Planning Commission Staff Report

SPECIAL USE PERMIT CASE NUMBER: WSUP20-0013 Ormat Geothermal

BRIEF SUMMARY OF REQUEST: Special use permit for renewable energy production, utility services, hazardous materials, major grading and to vary parking, landscaping, and grading standards.

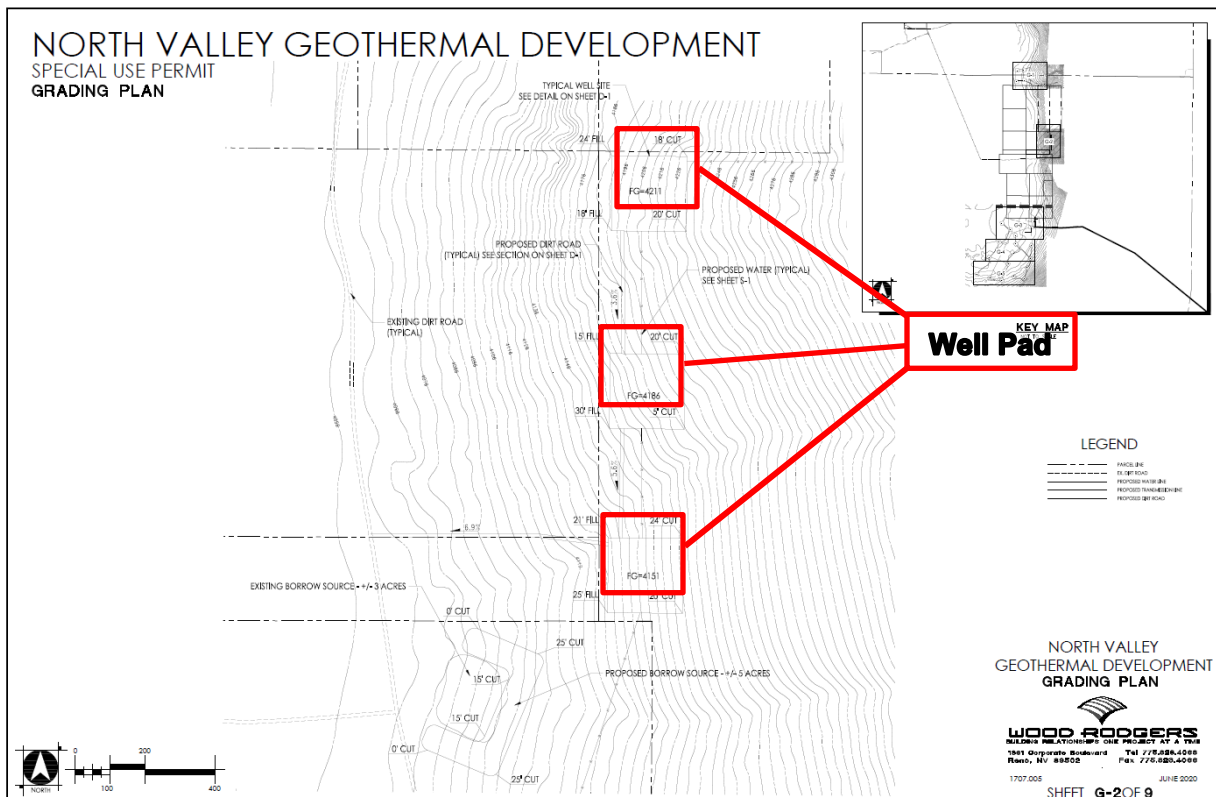
Staff reviewed the plans in detail. Sheet G-2 shows the location of three well pads between 25ft and 40ft of the property line, as seen below:

Any permanent structures on in these well pads on sheet G-2 must comply with the required GR setbacks. All other well pads and structures are clearly within the setback envelope and meet the height requirements.

Sheet G-2 (Zoomed in)

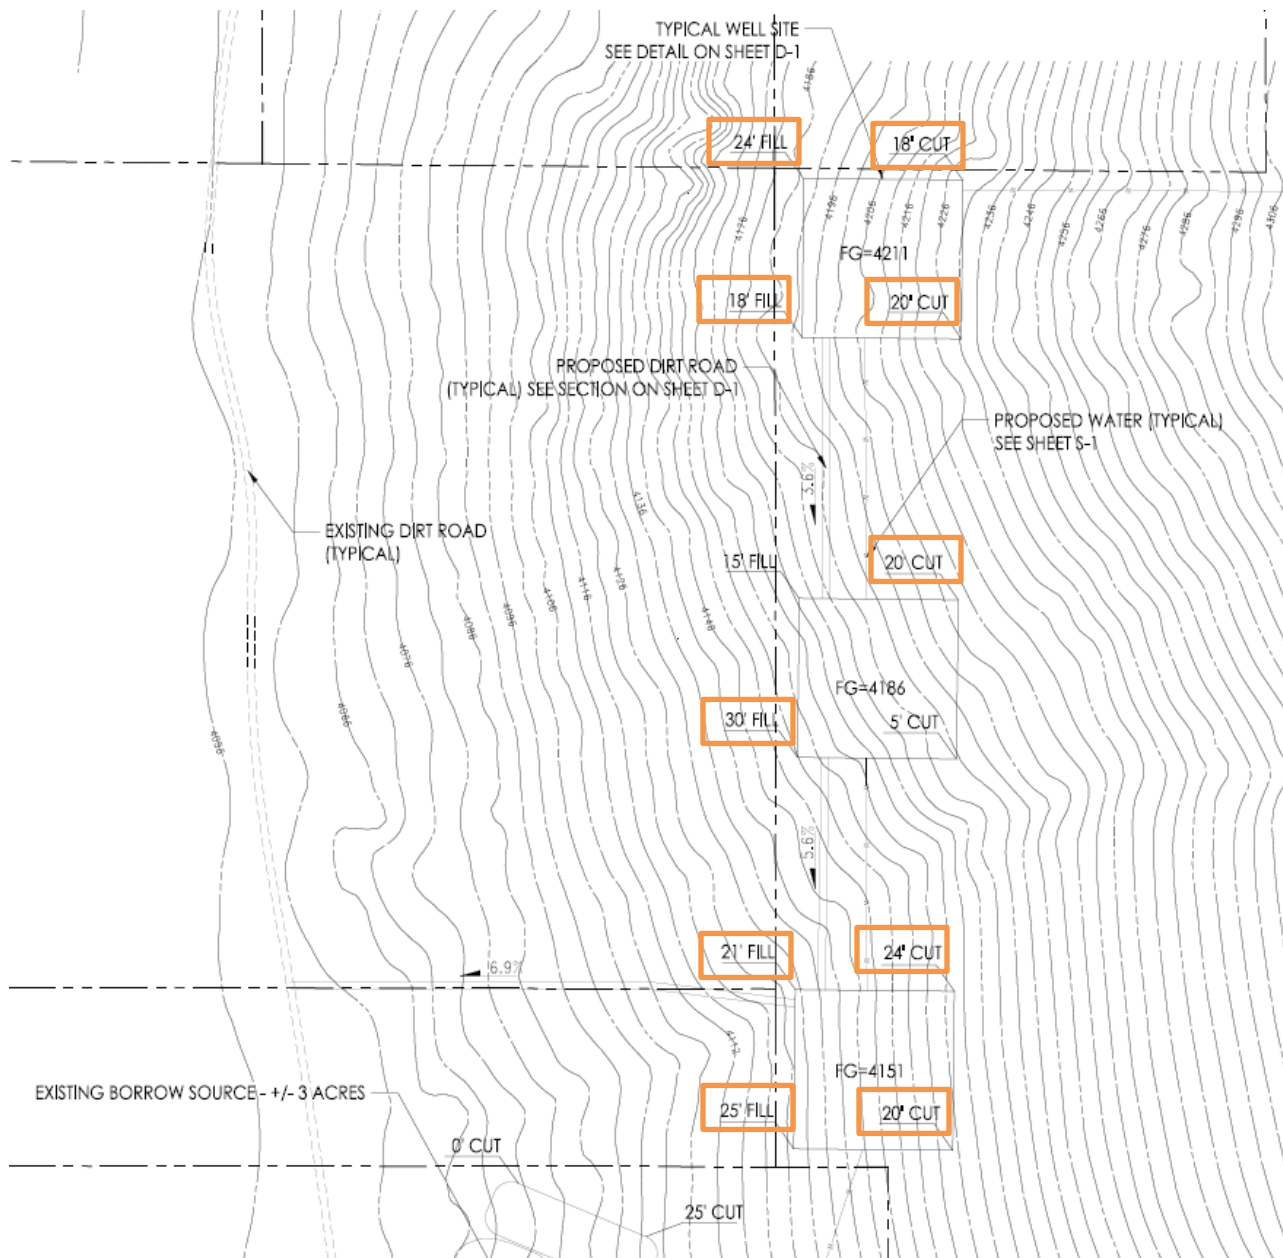
The applicant is requesting to vary the 10ft maximum height difference from natural grade for the entirety of this project in order to preserve flexibility in siting geothermal well pads across the site. This request is currently applicable to the well pads listed on sheet G-2 (above) which shows cuts and fills ranging from 15-30ft in height. The nature of geothermal exploration means that the placement and number of wells for this project depends on the availability of geothermal resources. This may require that some of the wells may be placed in more topographically constrained areas in order to maximize the geothermal efficiency while minimizing the required grading across the site overall through a reduction in required well pad sites. Therefore, staff agrees that waiving this standard is reasonable in order to preserve placement flexibility and potentially reduce the required

Comment #9 (EA, page 3-53)

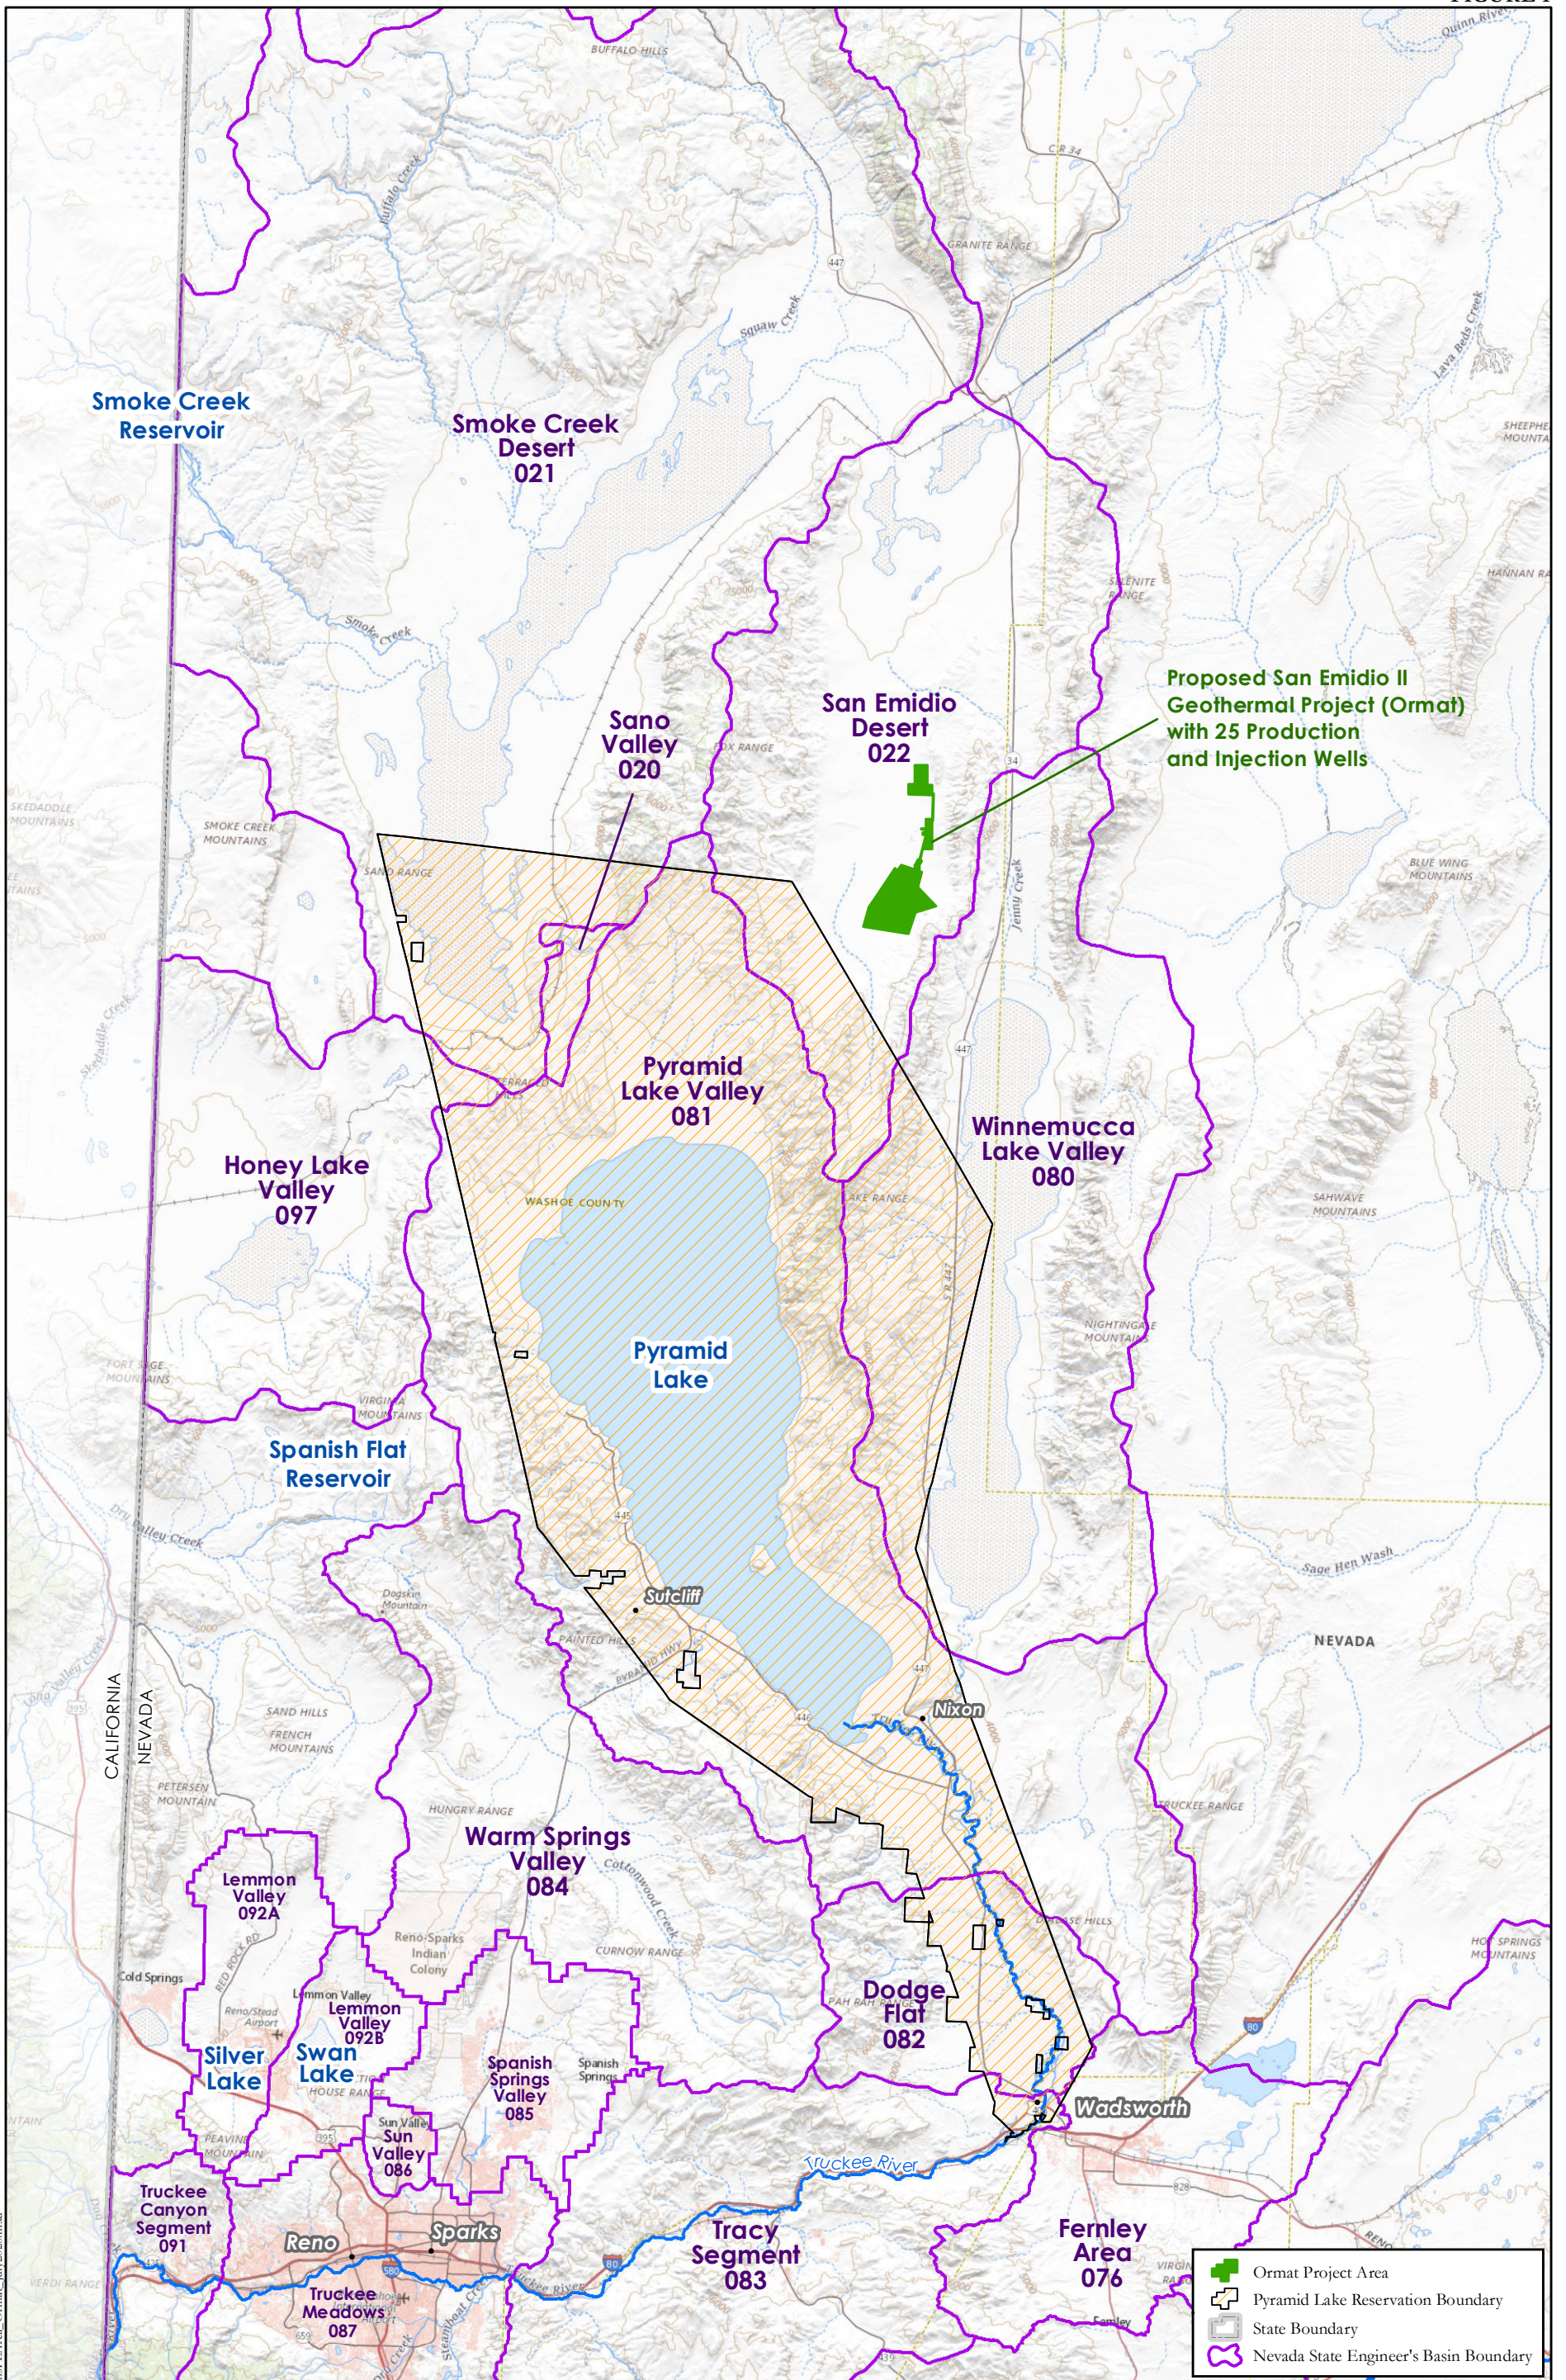
The following comment is made in the EA in regard to cumulative effects:

"Because there is a lack of connectivity between the geothermal resource in the San Emidio Desert Basin and undeveloped geothermal resources in adjacent hydrologic basins, Alternative A is not anticipated to prevent development of these resources in the future. Similarly, there is no direct connection between the geothermal resources in the San Emidio Desert and groundwater and surface water resources in the Pyramid Lake Valley basin; thus, there would be no contributions to cumulative effects on water quality or quantity in Pyramid Lake, including habitat for listed fish species."

There is no conclusive scientific bases or analyses in either the EA or the Hydro Report to support these statements. The capacity and extent of the geothermal resource from which the proposed Project will withdraw from are not stated, quantified, or otherwise illustrated in either the EA or the Hydro Report. The analyses and information that are provided in the Hydro Report conflict with the statements that are made regarding no effects.

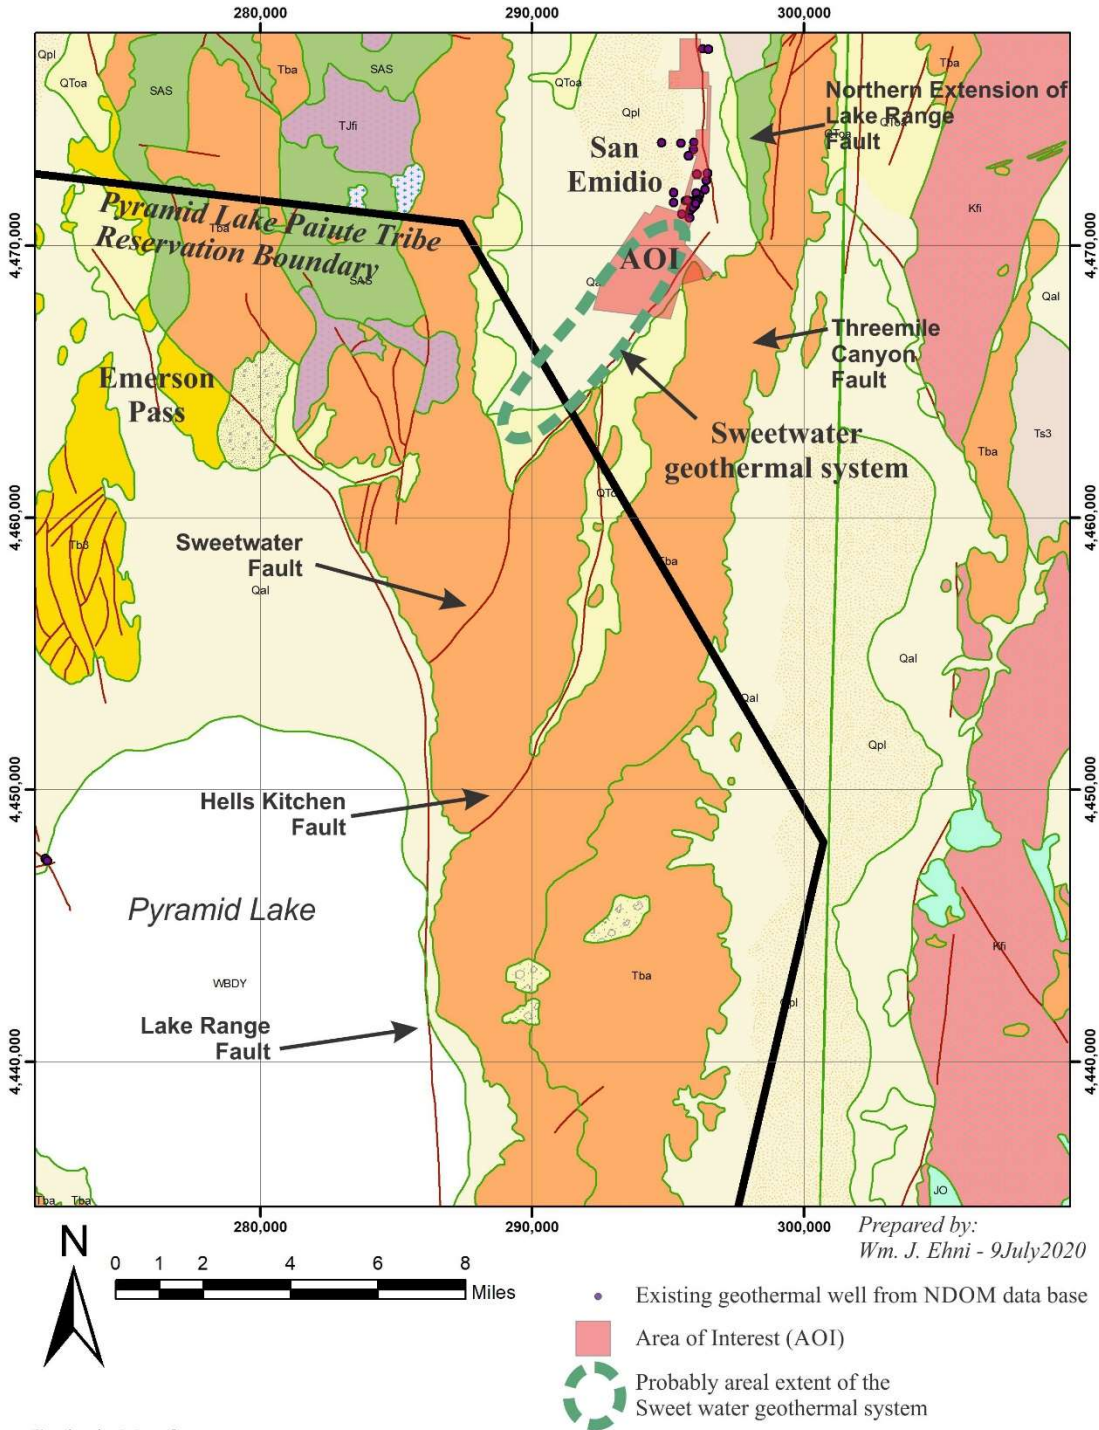
The report emphasizes that the geothermal system is fault controlled but then states that “These north-northeast striking structures appear to be geologically independent of the Lake Range, Fox Range, and Pyramid Lake faults, which appear south of the Project area”. There are no temperature gradient or isotherm maps in the hydrogeologic evaluation that support this conclusion. Folsom (2020, Figure 1) presents an isotherm map at 30m below ground level; however, as Warren(2018) points out, the San Emidio geothermal resource is hotter to the south (towards the PLPT reservation) and the anomaly is open-ended to the south. In Figure 1 of the attached map Ehni outlines the areal extent of the hypothetical “Sweetwater geothermal system”. The proposed North Valley Geothermal Development project is on the northeast end of the Sweetwater geothermal system. The right stepping right lateral Lake Range fault on the shores of the Pyramid Lake, and the Northern Extension of the Lake Range Fault adjacent to the existing San Emidio project, are connected by the dilational Sweetwater and Hell’s Kitchen faults. The hydrogeologic evaluation completely misses this correlation. The San Emidio geothermal resource is located on the north end of the dilational Sweetwater extensional (NW-SE tension) fault zone which connects the northern extension of the Lake Range Fault in the San Emidio

basin with the Lake Range fault in the Pyramid Lake basin. As pointed out by Warren (2018), the San Emidio geothermal anomaly extends to the south, which is where the Sweetwater fault is located. The hydrogeologic evaluation failed to show the relationship of the hottest portion of the San Emidio geothermal system and the Sweetwater fault. On Page 2-2 the Hydrogeologic Evaluation states that “The San Emidio and Empire faults are in and most closely associated with the Project” and as depicted on the Figure 3 of the Hydrogeologic Evaluation, the Empire fault is actually the northern extension of the Sweetwater fault (Faulds et al 2013, Anderson and Faulds 2013, Crafford 2007). It should be noted that The Faulting on Figure 3 of the Hydrogeologic Evaluation is not consistent with other published maps (Faulds et al 2013, Anderson and Faulds 2013, Crafford 2007). The Lake Range Fault on Figure 3 splits at Hells Kitchen and on figure 3 the Hells Kitchen fault is called the Lake Range fault. If this is correct, then the Lake Range fault that appears to supply the hot water for the Pyramid Hot Springs is the same fault that San Emidio is on. On Page 4-6 of the Hydrogeologic Evaluation states that “The Lake Range fault extends from the southeastern shore of Pyramid Lake, branches off into an east-northeast-striking oblique fault, and terminates southeast of Wind Mountain Mine” which basically says that the Lake Range fault connects Pyramid Lake with San Emidio. However, it is most likely that the Lake Range Fault and the Northern Extension of the Lake Range Fault are components of a “right stepping, right lateral” fault system and the Sweetwater-Hell’s Kitchen faults are dilational or transitional pull apart geothermal zones as noted on figure 6 of the Hydrogeologic Evaluation. The fact that there are no maps of the fault system in the EA, and that the fault system is poorly described with conflicting statements, supports the recommendation that the proposed development, if approved, will need a robust monitoring program, directed by the PLPT, in order to protect the resources of the PLPT.
